## Meeting Agenda Plat Committee

Monday, October 10, 2022

1. [KPB-4659](#) Clam Gulch Heights 2022 Addition; KPB File 2022-136

2. [KPB-4660](#) Kachemak Estates 17; KPB File 2022-144

SCALE 1" = 100' AREA = 9.169 acres  
3 August, 2022

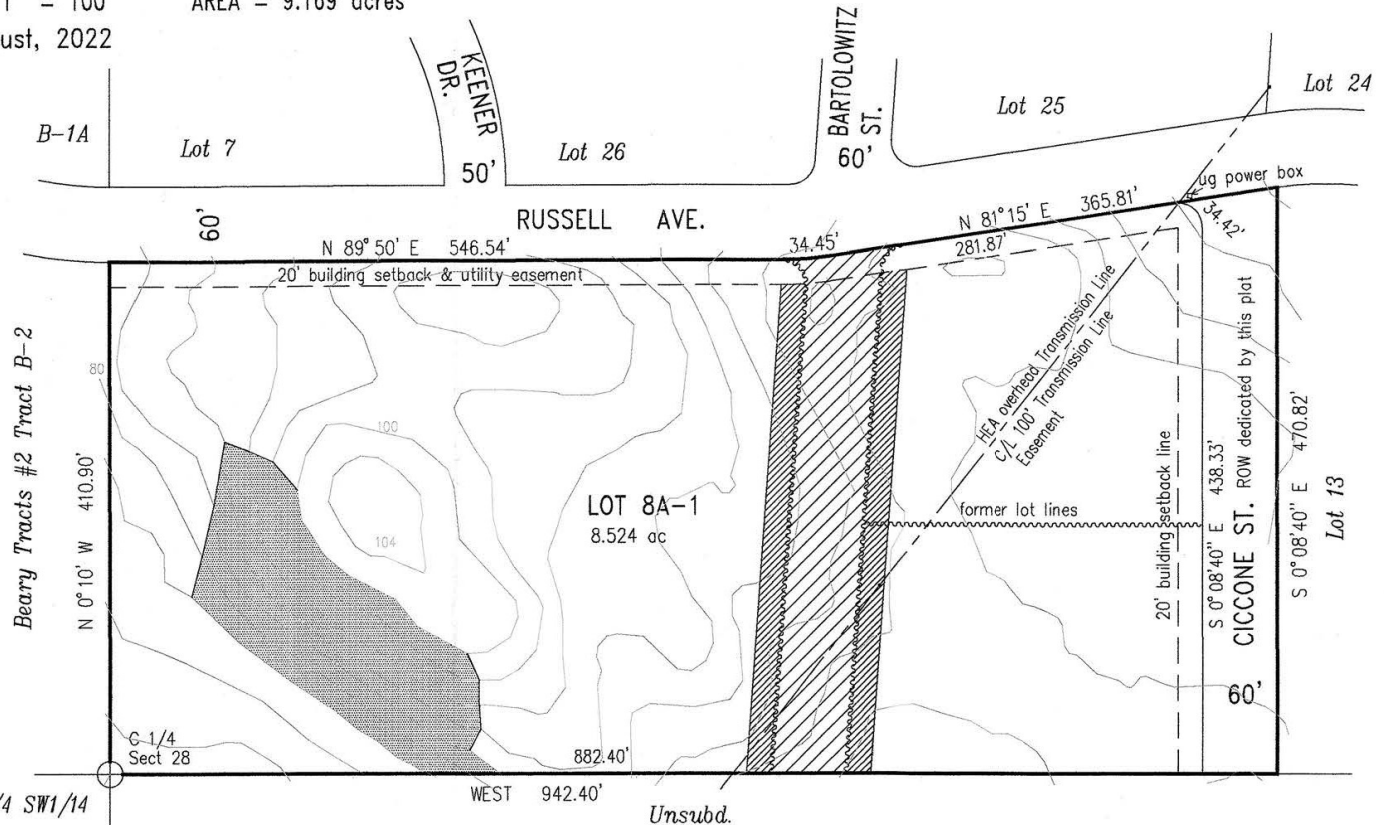
Street includes the utility easements as shown on the plat. The plat will have a 20 foot utility easement along Russell Avenue within the former right-of-way. The plat does not indicate the utility easement intention along the new dedication. Code only requires 10 foot utility easement. **Staff recommends** the easement along the western boundary be depicted and labeled as being granted by Plat KN 72-61, the 20 foot utility easement along Russell Avenue be labeled as being granted by Plat KN 81-135, note that the transmission easement was granted by Plat KN 72-61, and either add to the description along the new dedication "and utility easement granted by this plat" or depict a 10 foot utility easement with a label "granted by this plat".

The plat was submitted to the utility providers for comment. Homer Electric Association noted that there is an existing overhead line within the southwest corner of the subdivision and requested a 30 foot easement centered on existing line including guy anchors. **Staff recommends** the line be located and depicted with the easement being granted as requested and noted that it is "granted by this plat."

**Staff recommendation:** In the first line of description, add a space between 12 and 13. Remove “17, 18 (KRD 81-135)” from the third line.

*Within plat note 1, correct the parent plat number.*

*Within plat note 2, correct the spelling of utility.*

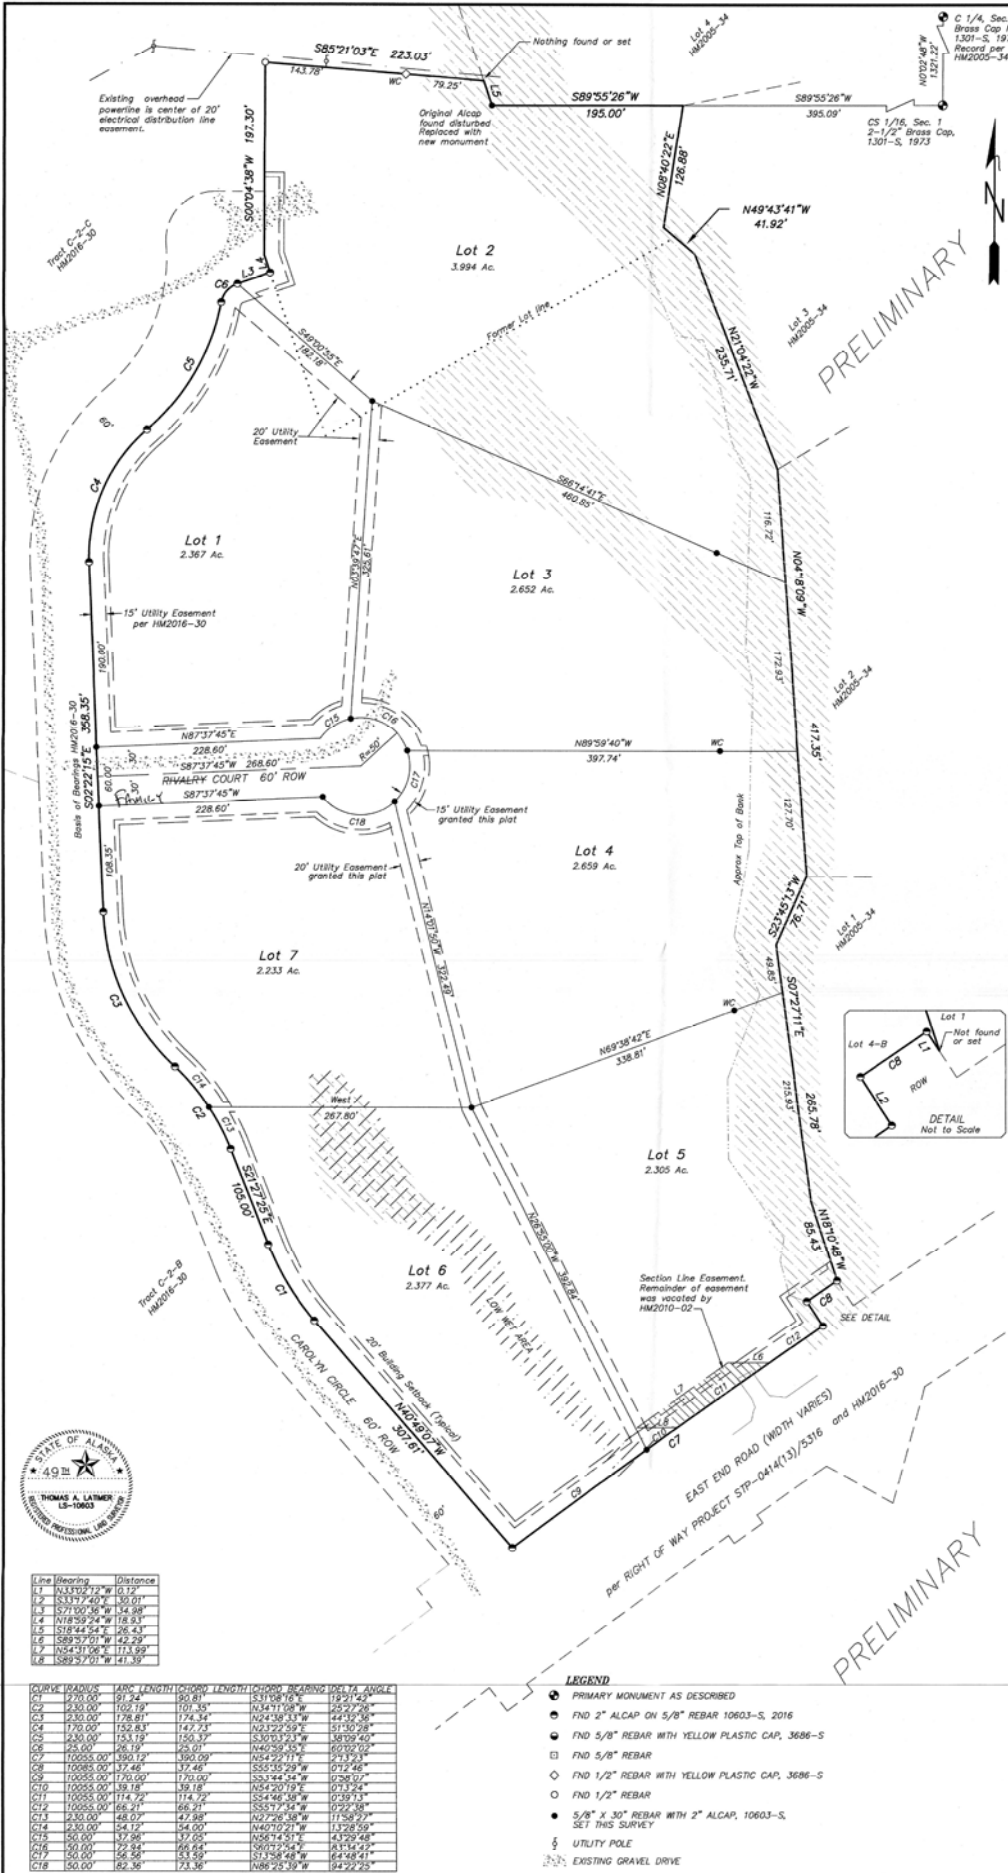
**Site Investigation:** The proposed plat contains a few areas with steep slopes. The slopes do not appear to impact the right-of-way dedication or the existing Carolyn Circle. The majority of the steep terrain is found along the eastern boundary. This area contains a creek. Plat note 3 indicates there may be some seasonal flooding in that area. In addition to the wetlands around the creek there are a few other areas with low wet areas. The correct plat note regarding a wetland determination is present and shall remain on the final plat. The wetlands and terrain appear to be shown on the plat but the shading should be better clarified. **Staff recommends the steep terrain and wetland depictions remain on the final and add the symbology to the legend.**

- Staff recommendation:** The lots from HM 2005-34 had a block designation that should be added to each lot.
- O. If the subdivision will be finalized in phases, all dedications for through streets as required by KPB 20.30.030 must be included in the first phase.

- Plat numbers need to be revised.
- Revise plat note 4 as this is within the City of Kachemak. "All new roads in the City of Kachemak must meet or exceed the design requirements of Kenai Peninsula Borough Chapter 14.06 per City of Kachemak Ordinance 2011-01."
- The Certificate to Plat included a newly issued easement to ENSTAR. This easement should be depicted and may refer back to a plat note with the easement specifications and recording information.
- Update the wastewater note for Lot 2, "The parent subdivision for lots resulting from this platting action was approved by the Kenai Peninsula Borough on December 4, 1978. Wastewater..."

**Staff recommendation:** The owners also took title without their middle initials. Add "aka" or "also took title as" and include their name as shown on deeds associated with this platting action. Comply with 20.60.190.

PLAT OF  
STUTES ESTATE

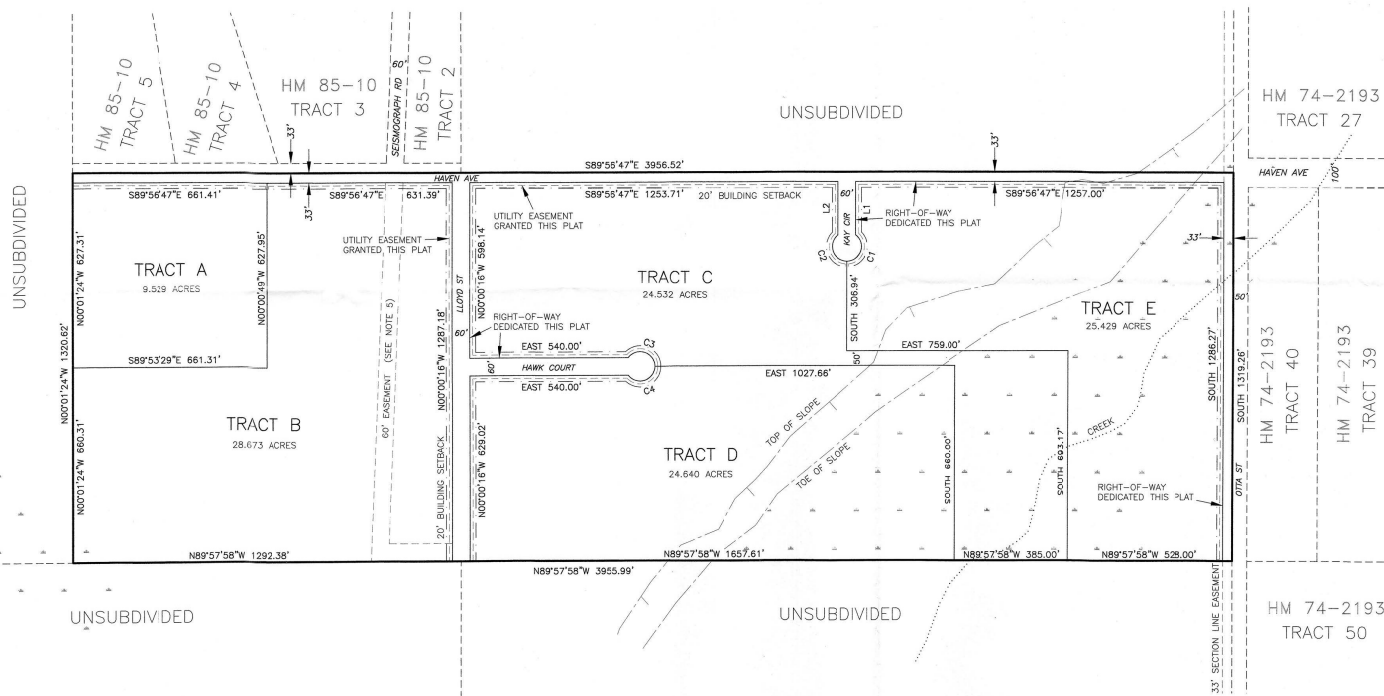
The plat is proposing to dedicated Haven Avenue atop the section line easements and provide a continuation from the already existing dedication. KPB data indicates that the section line easement to the north is 50 feet wide. This dedication will cross some steep terrain. *Staff recommends centerline profiles and cross-sections be submitted to determine if additional width or slope easements will be required, label the dedication to also state it is a section line easement and depict and label the abutting section line easement to the north.*

**Site Investigation:** The proposed plat has areas with steep slopes present. The plat shows the top and toe of the slopes. There is also an anadromous creek with wetlands surroundings it. The wetland determination note is present and should remain but an anadromous stream note will be required. **Staff recommends the top and toe of the slopes, the wetlands, and creek depiction remain on the final plat and add required plat notes.**

- Make street names more prominent for readability.
- On the cul-de-sacs, add a transition curve from the straight portion to the bulb.

**Staff recommendation:** *Verify the section line easements to the north and south of the subdivision.*

- Note any exceptions granted.
- If the narrow portion is increased to 60 feet wide add, "Tract D and Tract E are subject to a 20 foot building setback along the access portion of Tract C."

- If the narrow portion remains under 60 feet wide add, "Tract C may have future limitations on further subdivision based on access issues, development trends in the area, or topography."

- Revise plat note 1 to closer match code. "The front 10 feet adjoining dedicated rights-of-way that increase to 20 feet within 5 feet of the side lot lines is granted as utility easements per this plat."
- Revise note 3, "No permanent structures or wastewater disposal area is permitted within the panhandle portion of Tract C."

**Staff recommendation:** Add Mona Stutes title as Successor Trustee to her signature line. Comply with 20.60.190.
